SUNDRY NOTICES AND REPORTS ON WELLS

8. Well Name and No.
YATES C FEDERAL 20

9. API Well No.
30-015-24500

RE: Plugging and Abandonment Requirements, Conditions of Approval

Schematic - Proposed

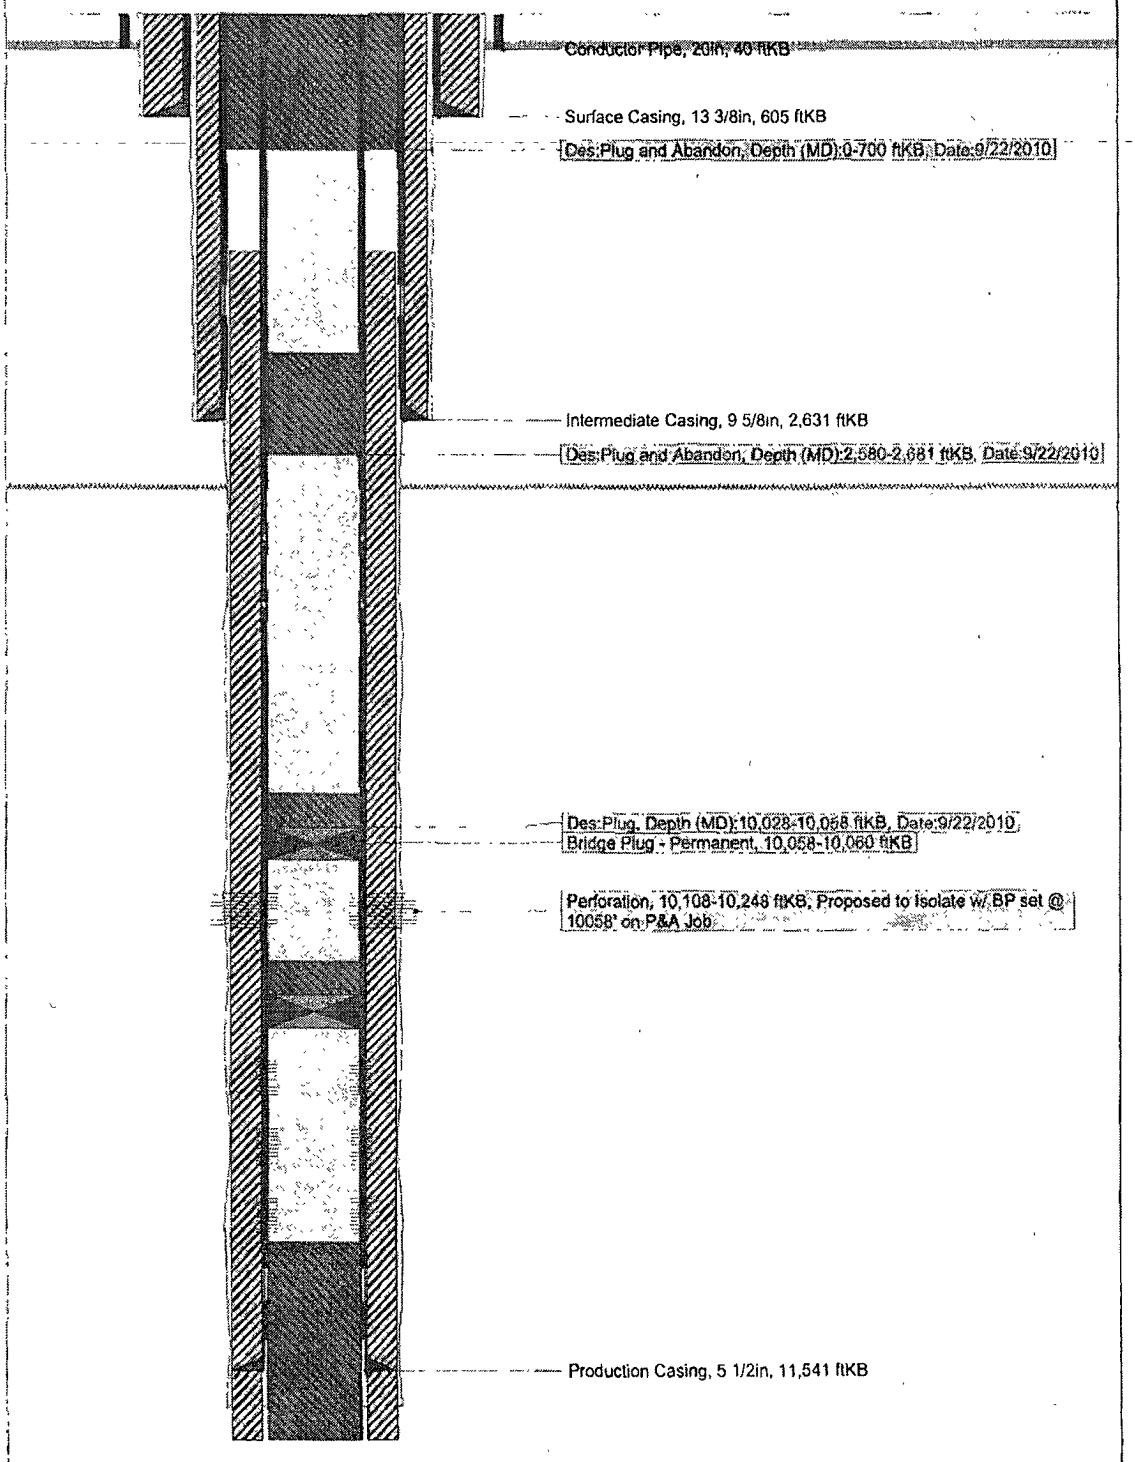
1. OK
2. OK
3. OK
3a. Drill out CIBP and cement at 10500'. Set CIBP at 10740' with 25sx on top.
4. OK (CIBP)
5. OK
6. OK (Perfs)
7. CBL to be run from below DV Tool at 5184 to show good cement up to that point. BLM to review CBL for possible changes before plugging above 5500'.
7a. Spot a plug (minimum 25sx) from 9080'-8890'. (Wolfcamp)
7b. Spot a plug (minimum 25sx) from 8400'-8230'. WOC and tag at 8230' or shallower (DV Tool)

All plugs below will depend on CBL on if they are spotted, or perforated and squeezed. Plugs will be set in all open annuluses. Some plugs may have an added WOC and tag.

7c. A plug is to be set from 5235'-5085' with a minimum 25sx. WOC and tag at 5085' or shallower. (DV Tool)
7d. Plug to be set from 4975'-4850' with a minimum 25sx. Can be combined with above plug. (Bone Spring)
8. Change: Plug to be set from 2681'-2551' with a minimum 25sx. WOC and tag at 2551' or shallower. (Casing shoe – Delaware)
9. REMOVED: Combined with above step.
10. OK (Casing shoe – Surface)
11. OK
12. OK
13. Verify that all annuluses have cement to surface and fill in as required – Otherwise OK
14. OK
15. OK
16. OK
17. OK
18. Submit a subsequent report to the BLM.
